AMENDMENT OF SOLICITATION / MODIFICATION OF CONTRACT			1. Contract Number	Page of Pages 1 12	
2. Amendment/Modification Number DCAM-2009-B-0011-004	3. Effective Date February 17, 2009	4. Requisition/Purchase Request No.	5. Solicitation Caption Construction of the Pedestrian Control System at One Judiciary Square

Please make the following revisions to Invitation for Bid # DCAM-2009-B-0011

**IFB No: DCAM-2009-B-0011 ATTACHMENT J.3
LATEST RESPONSE TO OFFERORS QUESTIONS**

DC Government @ OJS Lobby Optical Turnstile Plan [ROM-Rev 3]

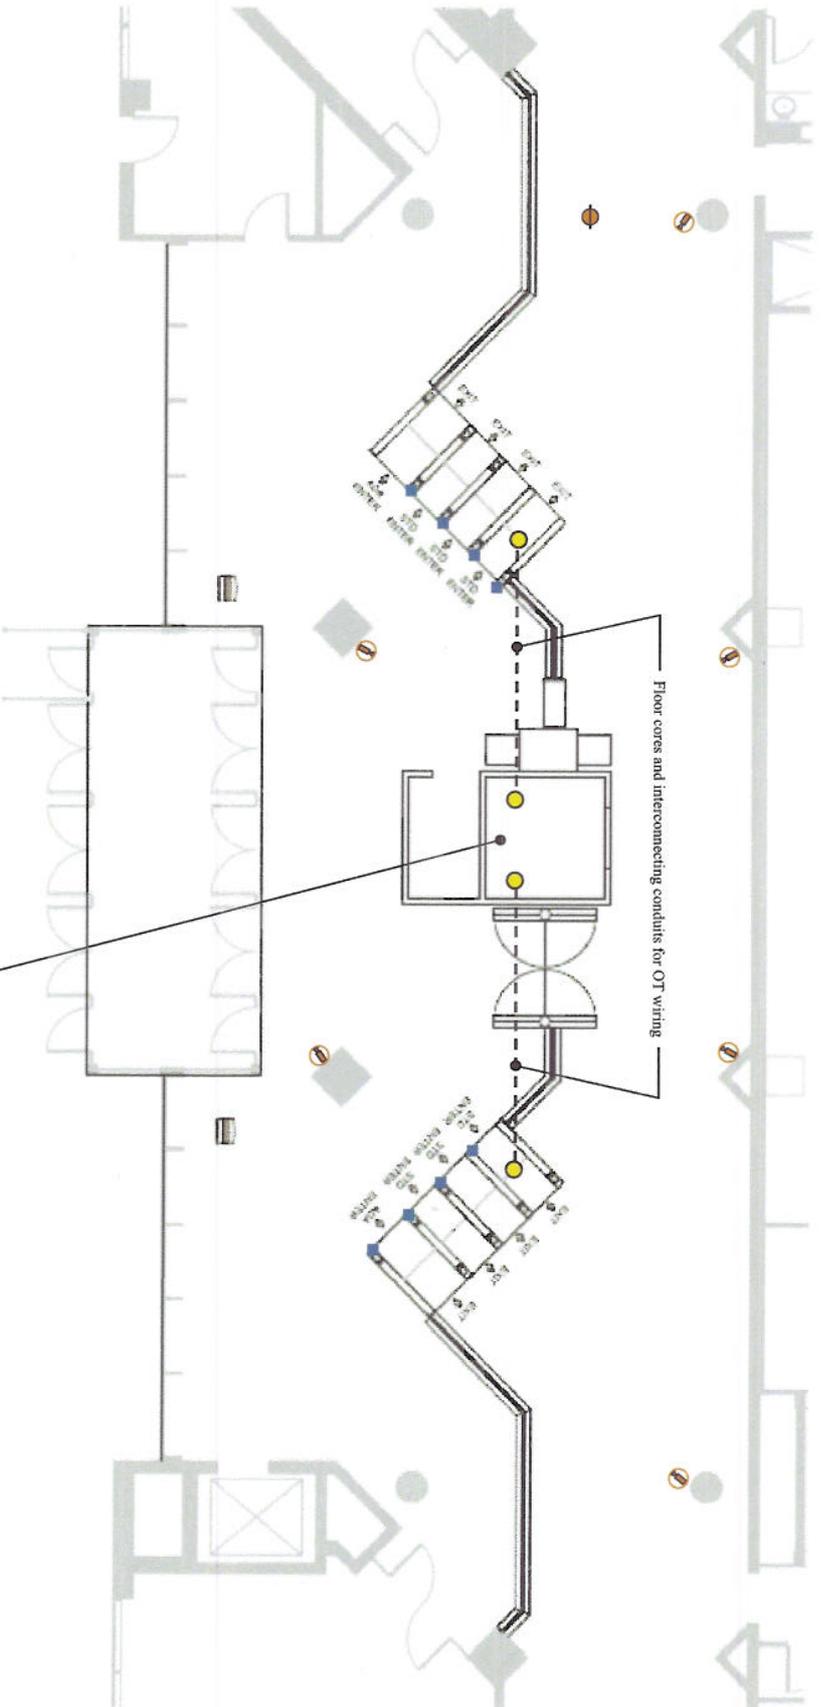
Question	Response
23	Page 6, the last sheet on drawings, regarding cameras, is this part of the scope? Is there any work for the electrical contractor?	The cameras are NIC and there is no work for the electrical contractor associated with the cameras.
24	Will a watchman be required?	Yes
25	Is there another ADT Contact person?	<p>Tom Mahoney is the ADT Contact. If you fail to get in touch with Tom Mahoney at (571) 338-4480 or tjmahoney@adt.com, please contact the following individual from the Office of Property Management:</p> <p>Jeffrey J. Ryder, PSP, CPP Interim Deputy Chief, Physical Security Protective Services Division DC Office of Property Management 1900 Massachusetts Ave, SE ACC Building, Second Floor Washington, DC 20003 Office: 202.698.8177 Mobile: 202.330.1893 Fax: 202.698.5091 Email: jeffrey.ryder@dc.gov</p>
